# **Authorized Field Change**

AFC G-07907R

Subject: Replace Water Pump Pulley on MaxxForce DT, 9 and 10 Engines

Engine Family: MaxxForce DT Engine Family: MaxxForce 9 Engine Family: MaxxForce 10

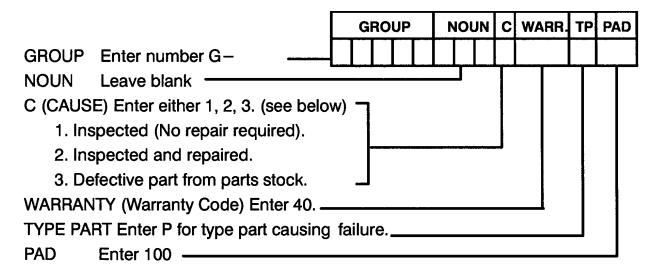
International Truck and Engine Corporation has determined that MaxxForce DT, 9 and 10 engines could experience a water pump pulley separation. Paint on the pulley surface is causing the mounting bolts to lose torque, allowing the pulley to come off.

- 1. Remove engine splash shield.
- 2. Loosen four M6 x 12 pulley bolts on pulley (Figure A).
- 3. Insert 1/2 inch square drive ratchet or breaker bar into belt tensioner square hole.
- 4. Rotate belt tensioner clockwise to release belt tension.
- Remove drive belt and release belt tensioner.
- 6. Remove four M6 x 12 pulley bolts and remove water pump pulley (Figure A).
- 7. Install new water pump pulley (Figure B). Tighten four M6 x 12 pulley bolts finger tight.
- 8. Insert 1/2 inch square drive ratchet or breaker bar into belt tensioner square hole.
- Rotate belt tensioner clockwise to release tension.
- 10. Install drive belt and release belt tensioner.
- 11. Torque four M6 x 12 pulley bolts 10 lbf-ft.
- 12. Install engine splash shield.
